ADDENDUM #1

Project: 5th & LIBERTY PARKING EXPANSION
Belleville, Michigan
HEI# 85320

BIDDER QUESTIONS & RESPONSES

SHEET
C-3

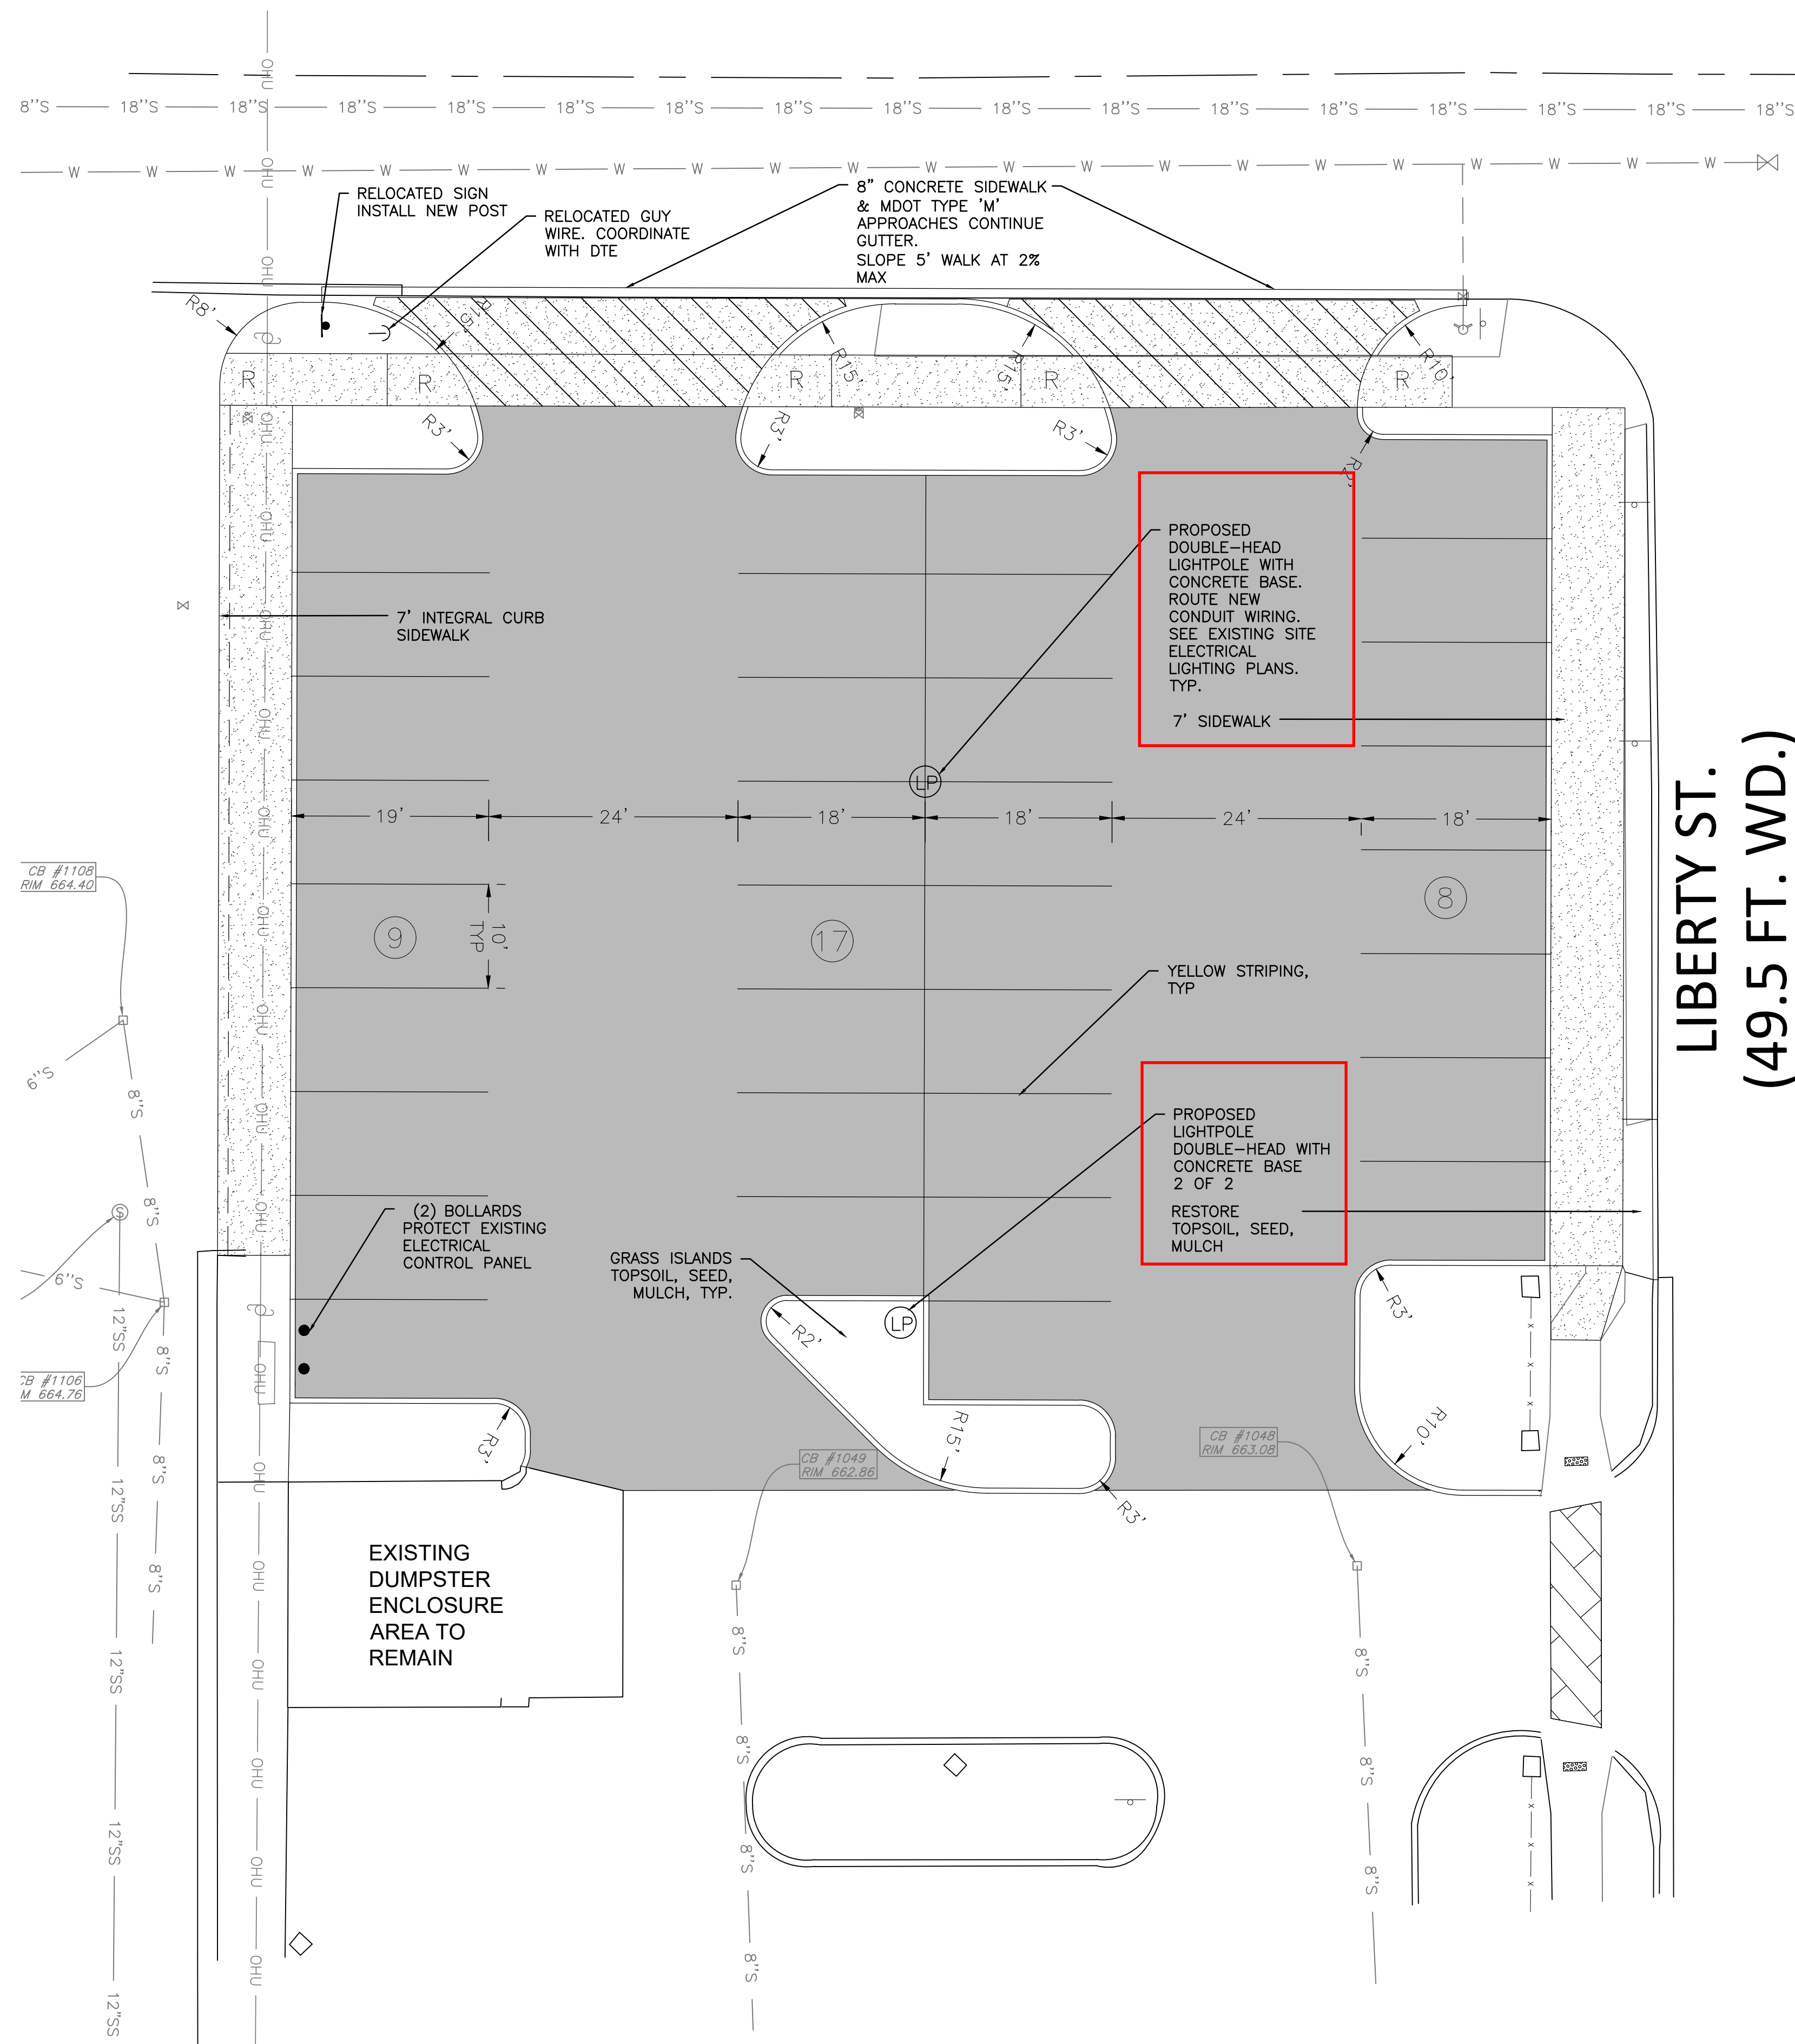
1. The quantities on the bid form don't match the drawings. 19 new poles are shown and bid form only has 2.

Response: There are only 2 proposed light poles in the project. The supplemental lighting drawings from the original project are for reference only. See attached plan.
